JRPP No:	2010SYW039
DA No:	527/2010
PROPOSED DEVELOPMENT:	Demolition, tree removal and the construction of a staged 3 storey residential flat building complex containing 106 apartments over basement car parking. Approval is also sought to use a portion of the building for community artist's space.
PROPERTY:	9 Albert Street, (Cnr O Connell Street) NORTH PARRAMATTA
APPLICANT:	DEM Pty Ltd on behalf of Housing NSW
OWNER:	New South Wales Land and Housing Corporation
REPORT BY:	Sara Smith

Assessment Report and Recommendation

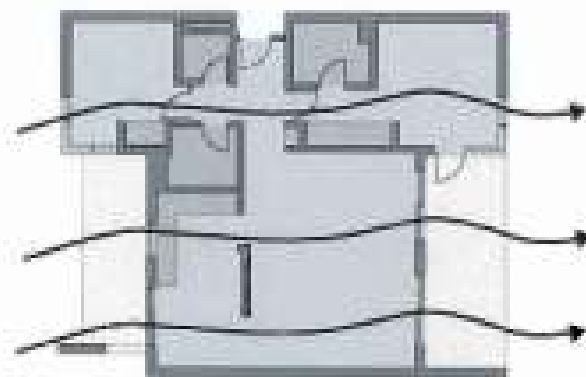
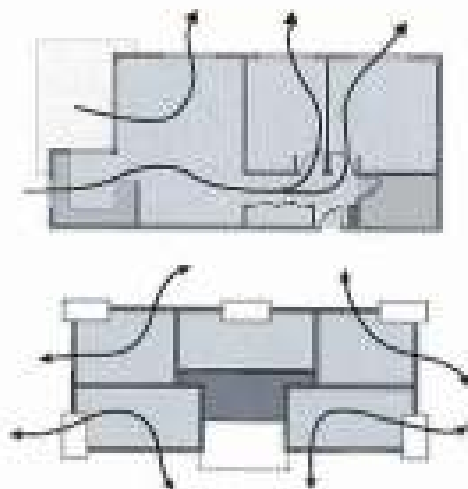
Panel Comments - Item 1. The panel is concerned in regards to assumptions made by the applicant to achieve Sepp65/RFDC cross ventilation requirements. The scheme proposes that internal central corridors are fully open in order to provide cross ventilation to a number of single aspect apartments via a Bedroom window opening onto the common corridor space.

The building forms and footprints have been carefully arranged to consider topography, maximising solar access to apartments and cross ventilation, and minimising overshadowing to open spaces. The open plan layout of the units is designed such that the balconies and private open spaces are an extension of the living spaces, therefore creating a seamless relationship between the indoor and outdoor living areas.

All individual units achieve a building depth range from 7.8 - 9.2m from the back wall of the kitchen to an external window in the living room; the efficient internal layout of the units enables good cross ventilation of the dwelling.

As a result of the Panel's comments we now propose that the living and dining areas on the top floor units are provided with roof ventilators, resulting in an additional 18% (6 nos.) of the units being

naturally ventilated. Therefore, 70% (23 no.) of the units within the development are considered to be naturally ventilated units. This is well in excess of the SEPP 55 rule of thumb of min 60% of the total number of units requiring natural ventilation. Refer to attached diagrams for further details, an—1201-1204 Rev A02.
